|  | Form C-103  |
|--|---|
| SUNDRY NOTICES AND REPORTS ON WELLS  | 7. Lease Name or Unit Agreement Name  |
| (DO NOT USE THIS FORM FOR PROPOSALS TO DRILL OR TO DEEPEN OR PLUG BACK TO A  | NORTHEAST DRINKARD UNIT <22503>   |
| OTHER: CHANGE SURFACE LOCATION & PROPOSED DEPTH  OTHER:  |   |

WELL LOCATION AND ACREAGE DEDICATION PLAT

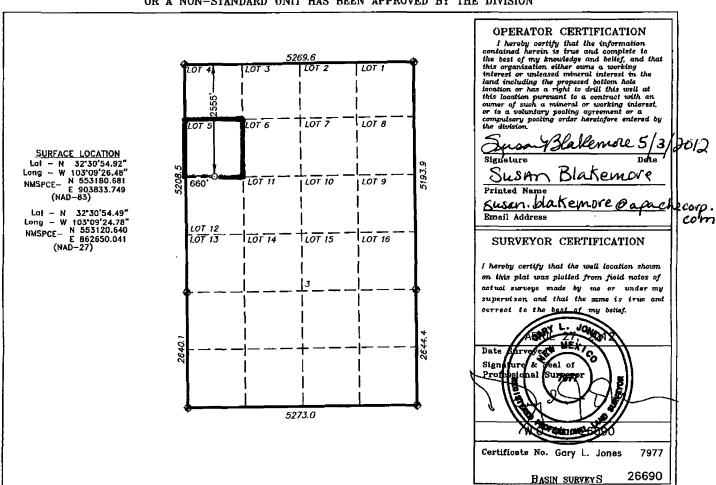
|  | Form C-103  |
|--|---|
| of starting any proposed work). SEE RULE 19.15.7.14 NMAC. For Multiple Coproposed completion or recompletion.  05/03/2012: APACHE CORP REQUEST: To change surface location of the NEDU # and 660' FWL to 2555' FNL and 660' FWL. UL: D Sec.: 3 T-21-S R of well from 8100' to 7200'.  Spud Date:  Rig Release Date:  | mpletions: Attach wellbore diagram of  160 (30-025-40498) from 2630' FNL  37E. Also to changed Proposed Depth   |

| UL or lot No. | Section | Township | Range | Lot Idn | Feet from the | North/South line | Feet from the | - East/West line | County |
|---------------|---------|----------|-------|---------|---------------|------------------|---------------|------------------|--------|
| LOT 5         | 3       | 21 S     | 37 E  |         | 2555          | NORTH            | 660           | WEST             | LEA    |
